# Nomad

# SERVICE BULLETIN

## INTRODUCTION OF FLITETRONICS PC125 INVERTER AS A REPLACEMENT FOR THE PC14C (BASIC) OR P14B(A) (MOD N228) TYPE INVERTERS

Figure 1 Conversion From Inverter Type PC14C To Inverter Type PC125

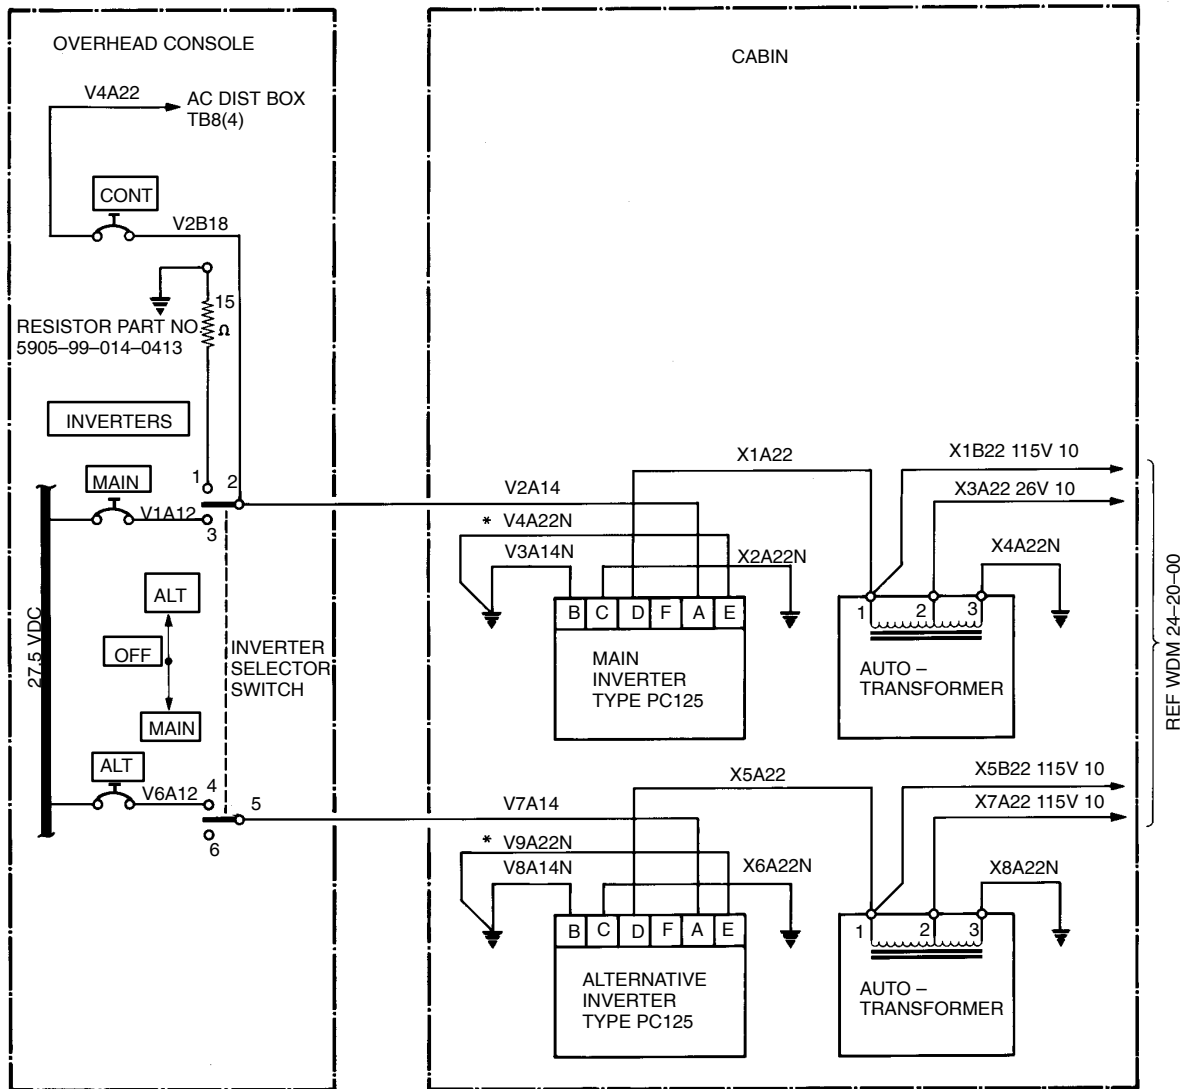
### A. **Part A – Replacement of Inverter Type PC14C with Inverter Type PC125 (Ref Figure 1)**

- (1) Remove the inverter type PC14C (Ref IPC Chap 24–20–0 Figure 1 item 7) from the aircraft (Ref MM Chap 24–20–00). Retain the attaching parts and note the order of assembly of wires and washers at the top two attaching points.
- (2) Remove the connector PN CA3106R14S–5S/F8 from the cable assembly and replace with connector PN CA3106R14S–6S/F8 connecting the wires to the connector pins as shown in Figure 1.

A new wire manufactured from 22 AWG and identified V4A22N (MAIN inverter installation) or V9A22N (ALTN inverter installation) is to be connected between Pin E and the same earthing point as wire V3A14N or V8A14N as appropriate.

\* NEW EARTH WIRE
